SAFETY RECALL

SR23-82

BAD GPS CONNECTION AT THE VECU CONTROL UNIT
9700 (B13R)

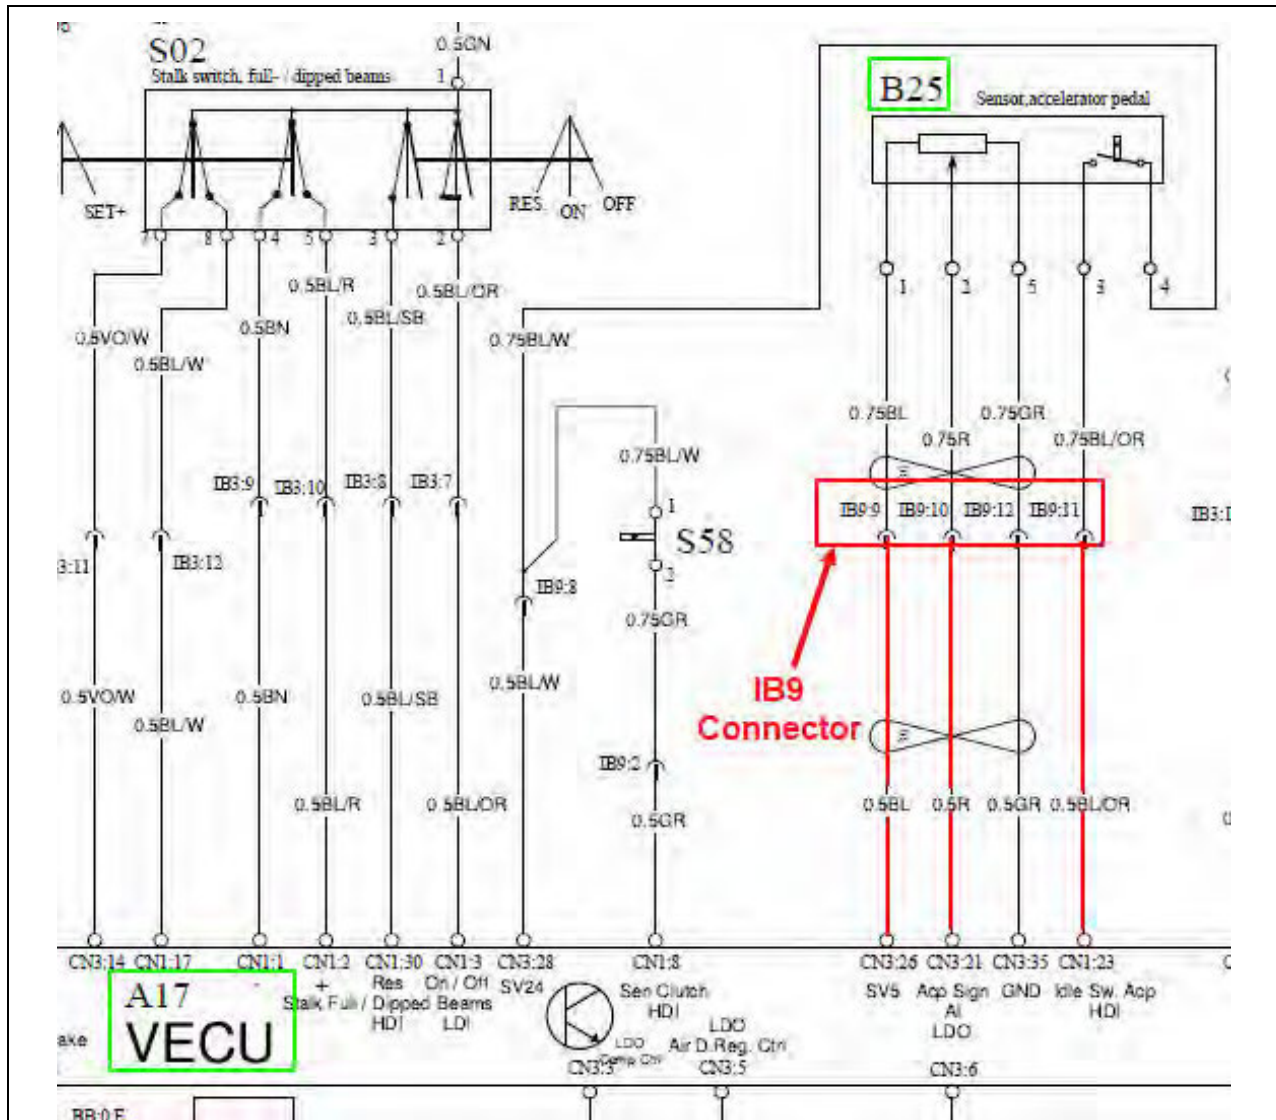
- The bad digital signal connection of the GPS is located between VECU (A17) and the throttle position sensor (B25), therefore; look for spliced GPS wires near the IB9 connector of the power distribution center in the vehicle electrical center compartment.

The digital signal of the GPS can be spliced to the wires located at PIN9, 10 or 11 of the IB9 connector as seen below.

- Once the GPS digital signal is located, remove it from the IB9 connector corresponding wire. This wire of the IB9 connector must be repaired to ensure proper "interference free" signal so the throttle response is back to normal operation. This will also resolve the VECU communication problem with the CAN network.
- Repair the wire using supplied butt splice connector and shrink tubing (solder the connection).

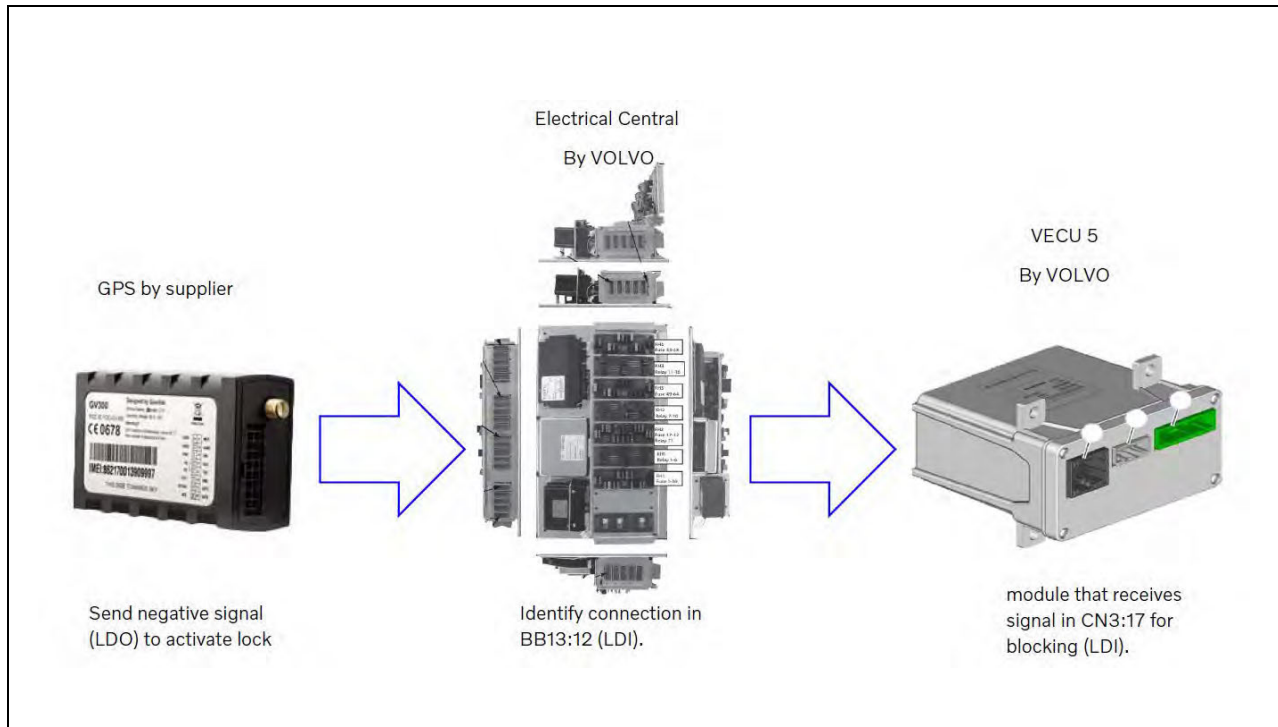
- The GPS must send a negative LDI signal(-) from the power distribution center located in the vehicle electrical center compartment to the VECU vehicle control module.
- To send the correct GPS signal, the GPS signal wire must be connected to PIN12 of the power distribution center BB13 connector (BB13:12). This connection will send the signal to PIN17 of the VECU control module CN3 connector (CN3:17 see wiring diag. BA).

Connect the GPS negative signal wire to the power distribution center using supplied wire and terminals (use shrink tubing and solder the terminals)
